PIC12F683 Rev. A Silicon/Data Sheet Errata

The PIC12F683 parts you have received conform functionally to the Device Data Sheet (DS41211D), except for the anomalies described below.

FIGURE 1: SILICON REVISION A1 VS. REVISION B1

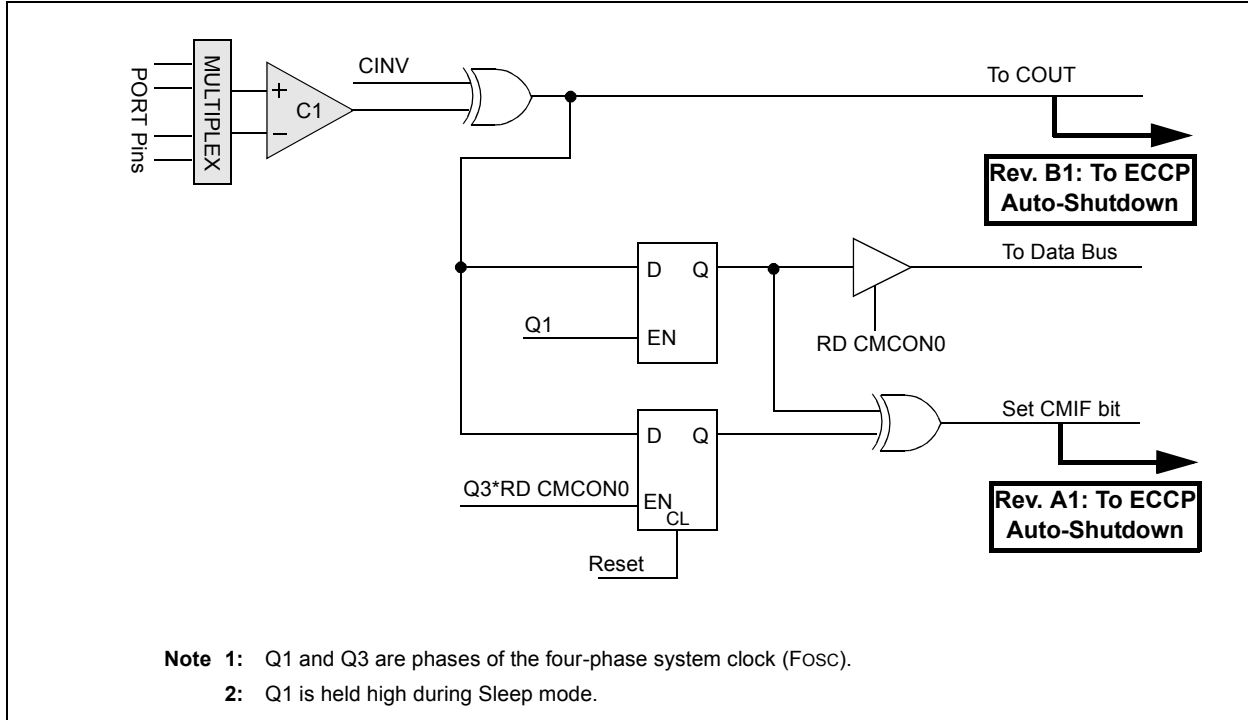
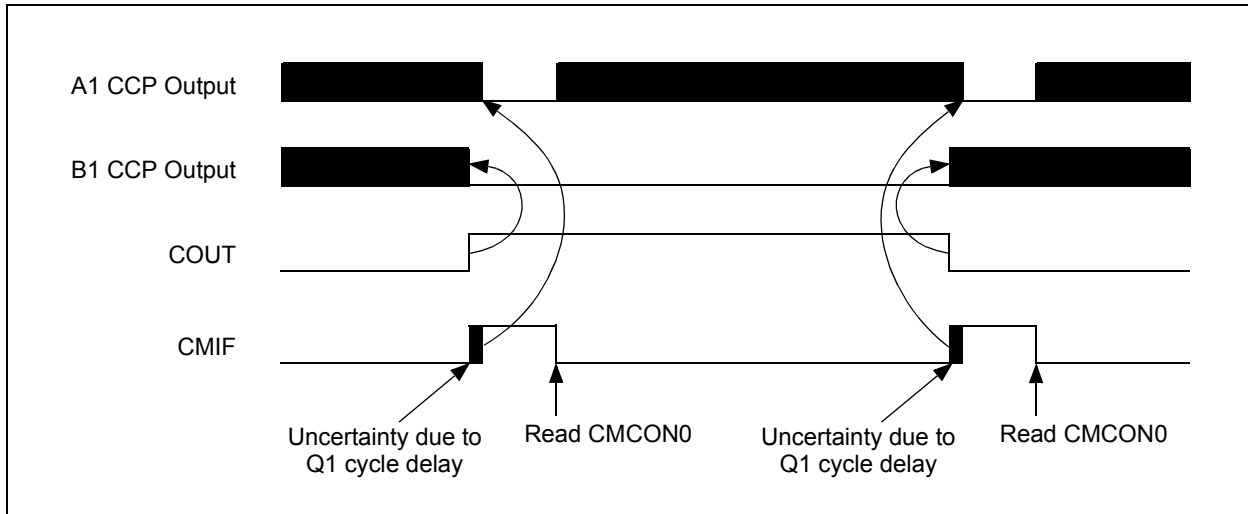
The PIC12F683 Rev. A1 silicon for the ECCP Auto-Shutdown is connected to the CMIF flag. See Figure 8-2 on the following page.

Rev. A1's auto-shutdown connection to CMIF causes the auto-shutdown to incorrectly operate synchronously. Additionally, reads of CMCON0 will incorrectly clear an auto-shutdown event.

The Silicon Rev. B1 device (now shipping) has moved the auto-shutdown connection from CxIF to CxOUT. This will eliminate the synchronous shutdown and simplify the use of the comparator for a shutdown event. Figure 1 shows the function of auto-shutdown before and after the device revision.
